Work Order ID 83183

Item Name: Crosstube Aft

DRAWING NO. D412-664-243	TITLE CROSSTUBE ASSEMBLY (412 HI AFT)	REV. E	DART AEROSPACE LTD ENGINEERING ORDER		D.E.O. NO. D412-664-243-E-1	SHEET NO. SHEET 1 OF 2	SCALE NTS
DRAWN	CHECKED <i>MP</i>	MFG. APPR. <i>E</i>	APPROVED <i>MP</i>	DE APPR. <i>MP</i>			
DATE 11.03.31	DATE 11/03/31	DATE 11.03.31	DATE 11/03/31	DATE 11.03.31

DRAWING NO. D412-664-243	TITLE CROSSTUBE ASS'Y (412 HI AFT)	REV. E	DART AEROSPACE LTD ENGINEERING ORDER		D.E.O. NO. D412-664-243-E-2	SHEET NO. SHEET 1 OF 1	SCALE NTS
DRAWN 97	CHECKED ASS	MFG. APPR. E	APPROVED MP		DE APPR. H		
DATE 11.09.07	DATE 11.09.19	DATE 11.09.19	DATE 11.09.19		DATE 11.09.19

D412-664-603 10
BENDING AND DRILLING DETAIL

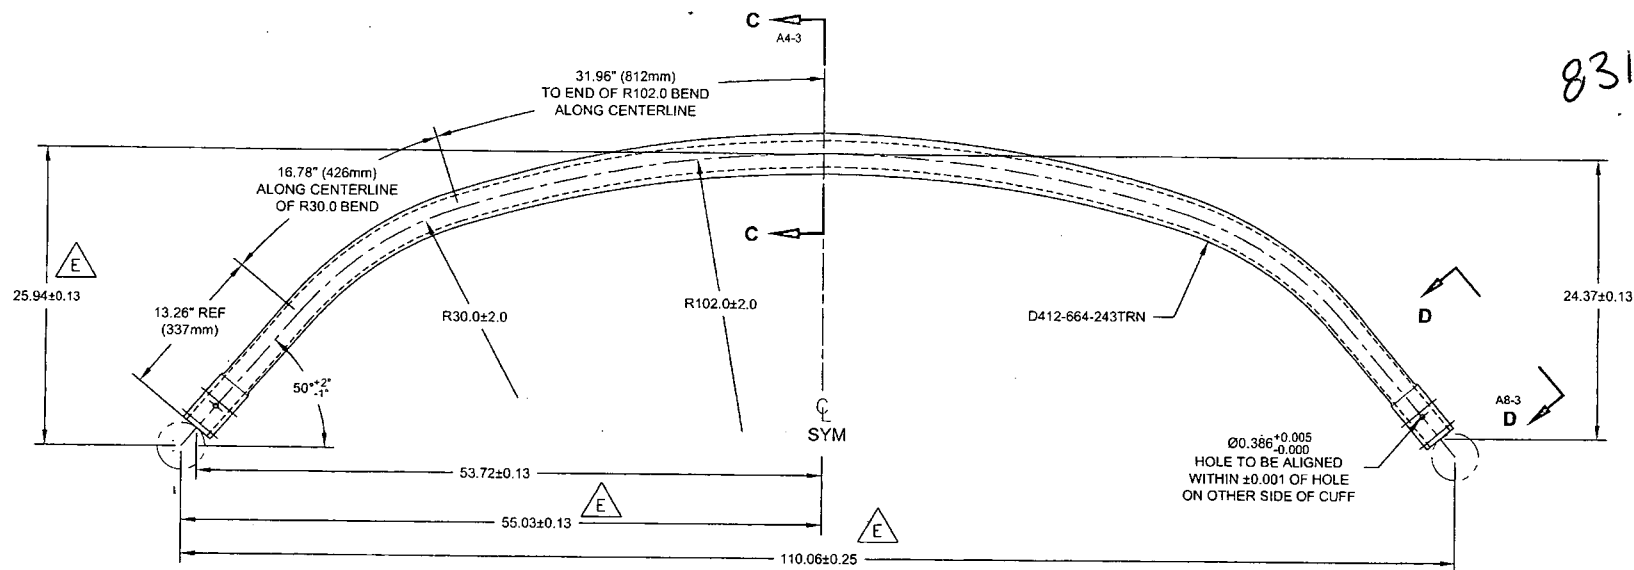
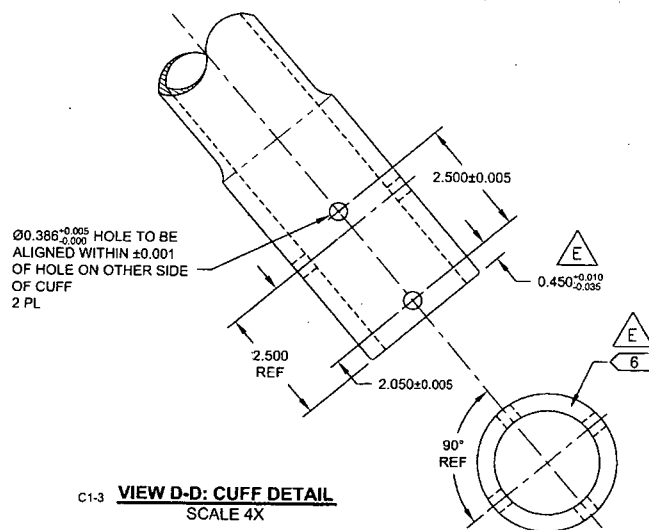
Comments	
→	Side A = 6.17% crush @ 24 passes
	Side B = 6.57% crush @ 28 passes

CRUSHING OF D412-664-243

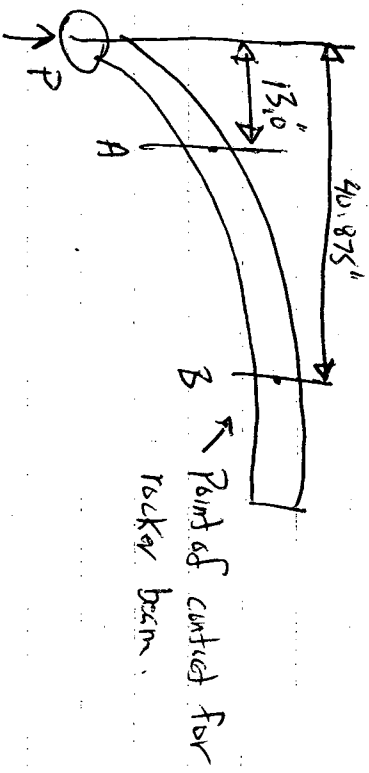
Acceptability of 8% CRUSHING AT END OF BEND

Point A: $\Delta D_1 = 2.961"$, $\Delta D_2 = 2.522"$

CRUSHING = $(2.961 - 2.522) / (2.961 + 2.522) = 8\%$
 $I = 1.676 \text{ in}^4$ (from AutoCAD)

Point B: $\Delta D_1 = 3.357"$, $I = 4.613 \text{ in}^4$

A: $F = M_c / I = P \times 13 \times 2.961 / 2 \times 1.676 = 11.484 \cdot P$
 B: $" = P \times 40.875 \times 3.357 / 2 \times 4.613 = 14.651 \cdot P$

M.S. = $14.651 / 11.484 - 1 = 0.27$

∴ Tube will break at rocking beam contact before area of 8% crushing, 8% crushing in area at end of tube bend is acceptable
